**RE:** Proposed Dredging Modifications in Cut 10

This memo is in response to EPA requests for clarification provided in Stephanie Vaughn's September 27, 2013 email

EPA Comments and CPG's response

Figure 3 - Cross Sections Showing Location of Sediment Samples in Areas North of Station 31+00 (1 of 6)

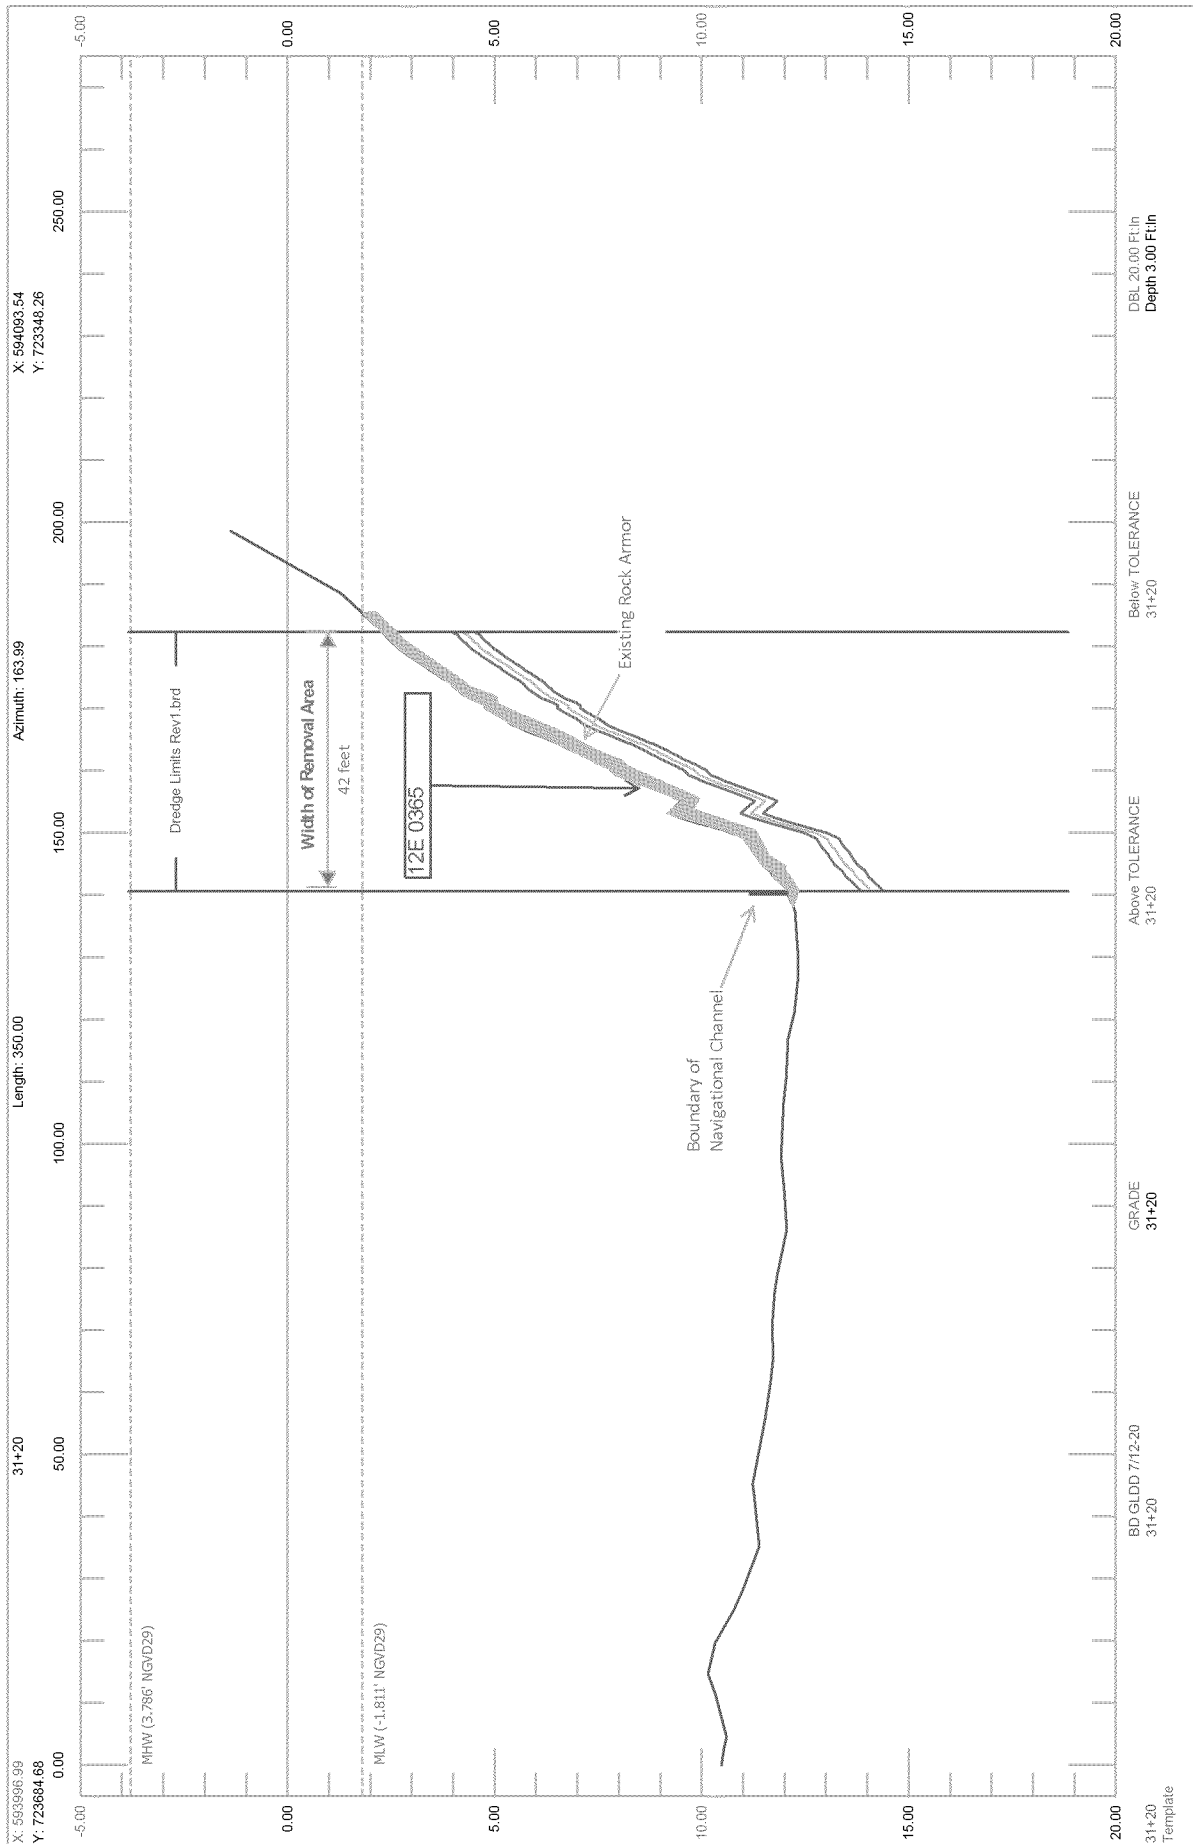
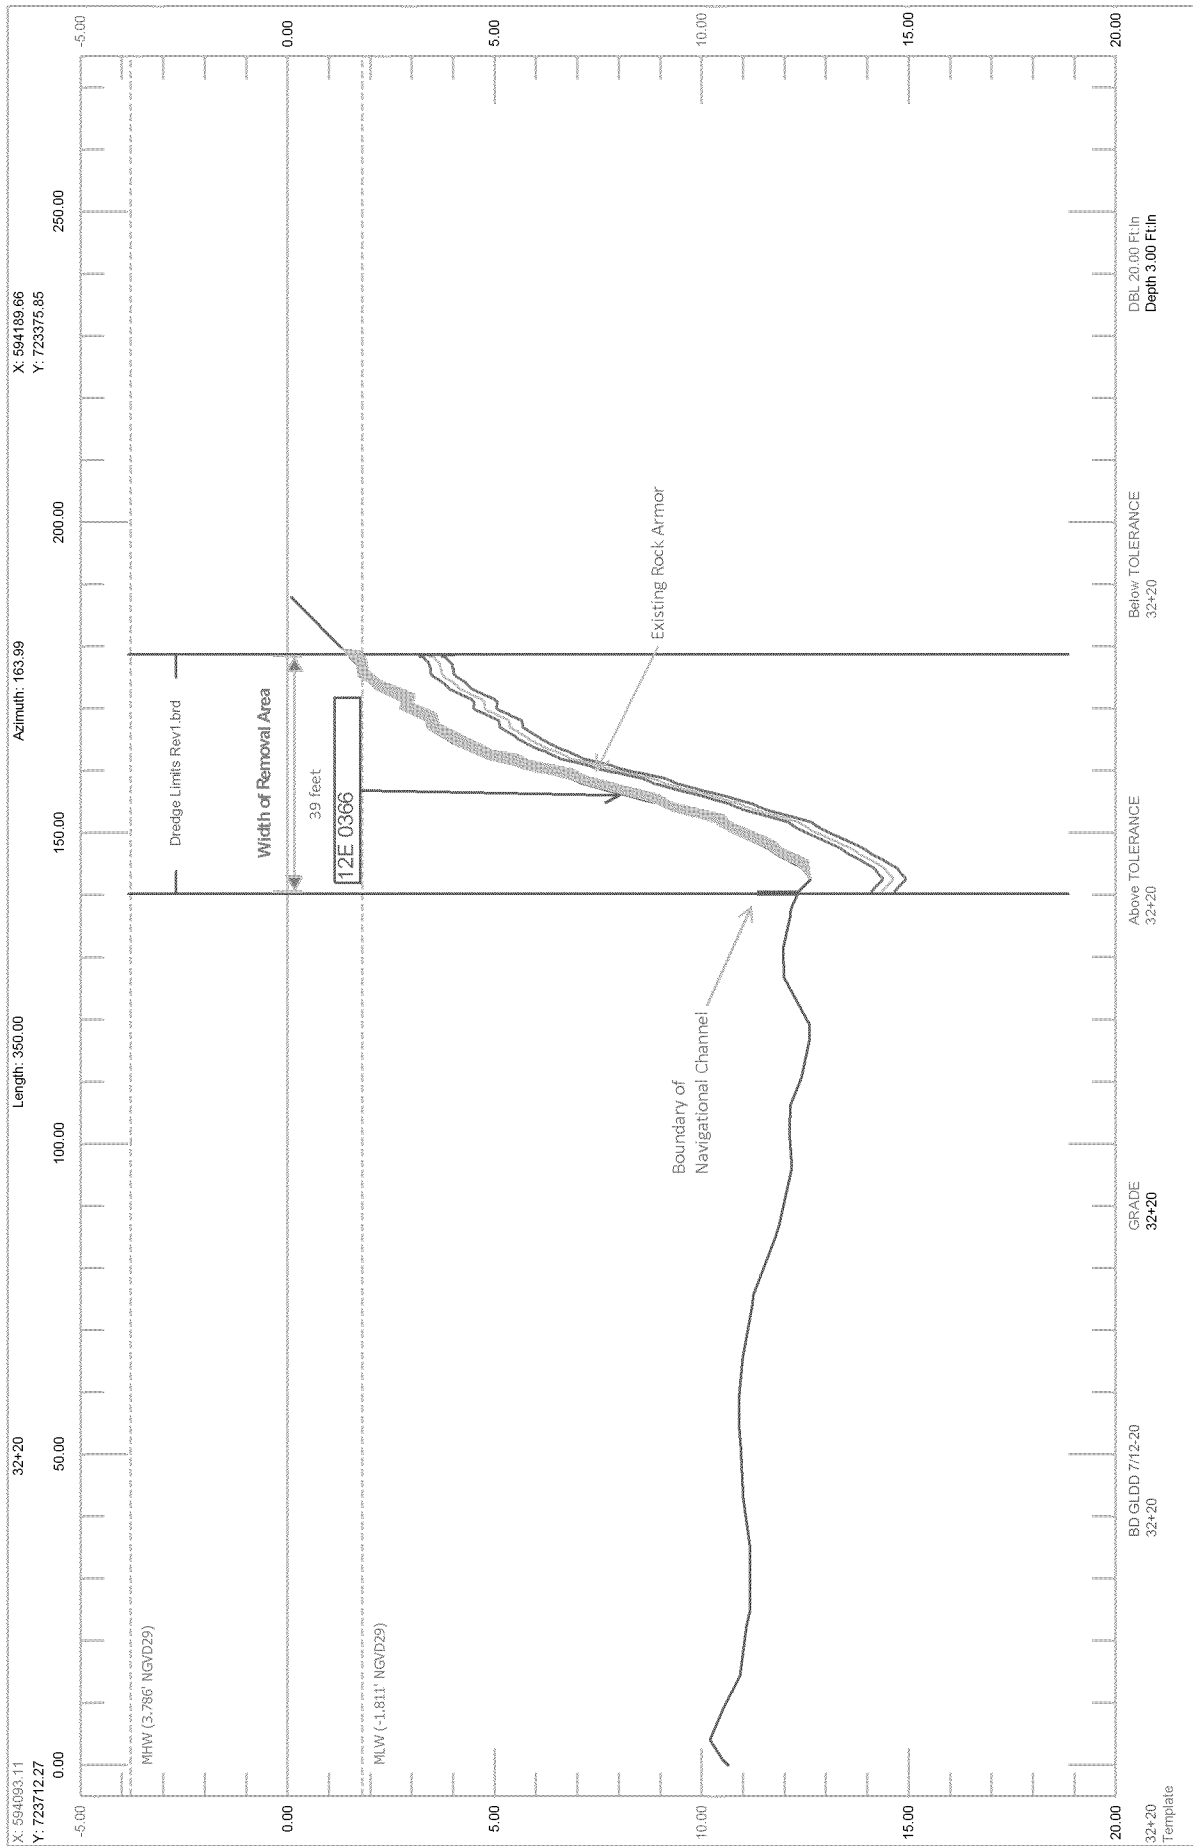
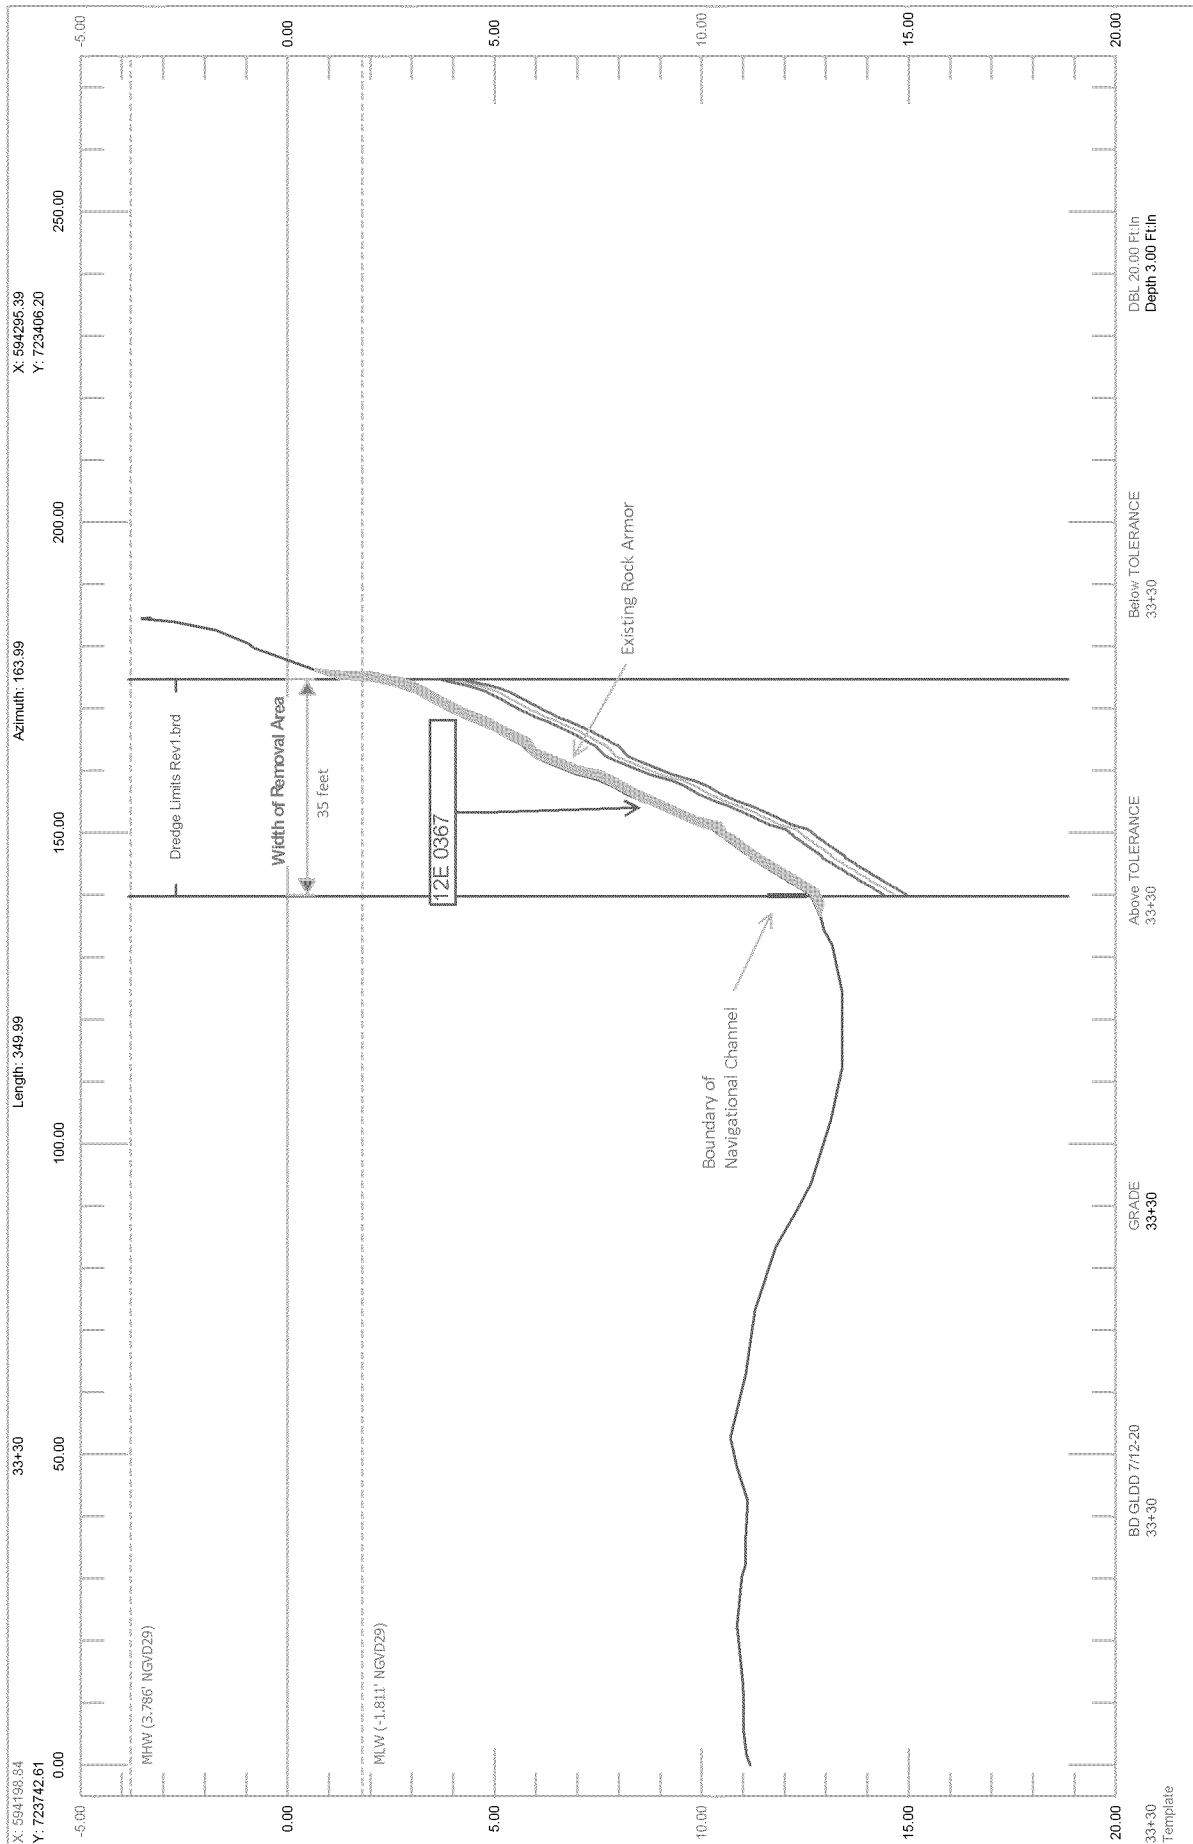
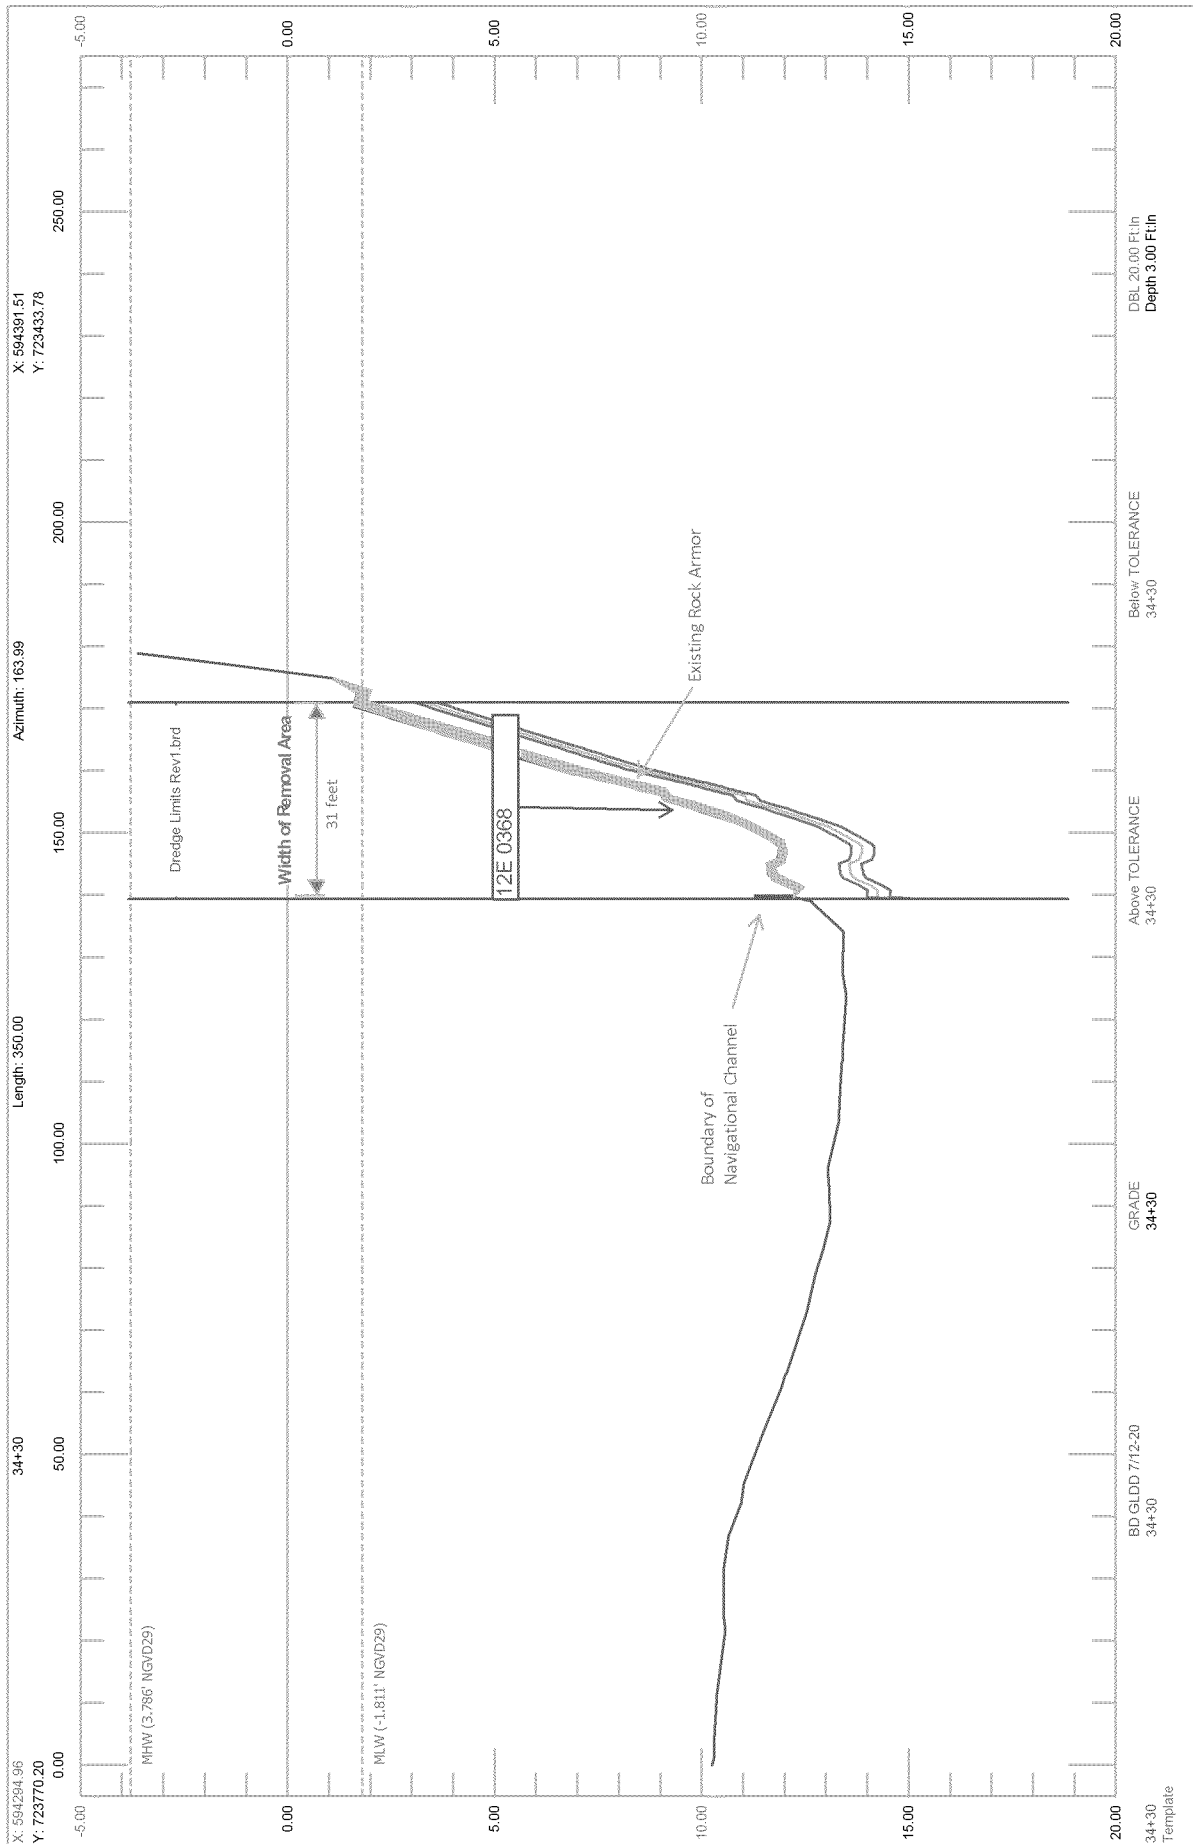
**2. *The width of the removal area is greater than 50' from Station 29+50 to Station 32+00, so at least some removal should be achievable in this area. After that, the width starts to trail off – but again, some removal should be achievable.***

- a. Dredging may be possible and will be attempted between Station 29+50 and Station 32+00 (which is beyond the area covered by the AOC). However, north of Station 32+00 the Removal Area narrows and the slope of bank increases to greater than 3:1, which is why the design indicated that this area could not be capped. The steep slope is the reason armor rock has been placed along this portion of the shore... to prevent potential erosion of the bank. This rock armor has been determined to extend to the toe of the slope, and the slope itself often extends to the boundary of the Navigational Channel.

- b. If there are areas where "dredgeable" sediment is present north of Station 32+00, CPG will attempt to dredge it provided that dredging will not remove the rock armor and destabilize the slope. However prior to that, CPG requests that EPA and/or CDM accompany the CPG's contractors on Monday afternoon to witness additional poling in those areas which, when combined with poling results obtained by GLDD on September 10 (see Attachment 1 which provides detailed findings from GLDD's previous poling in Cut 10), can form the basis for selecting the segments of Cut 10 where dredging could be attempted (see next section of this report for recommended poling and data interpretation procedures).
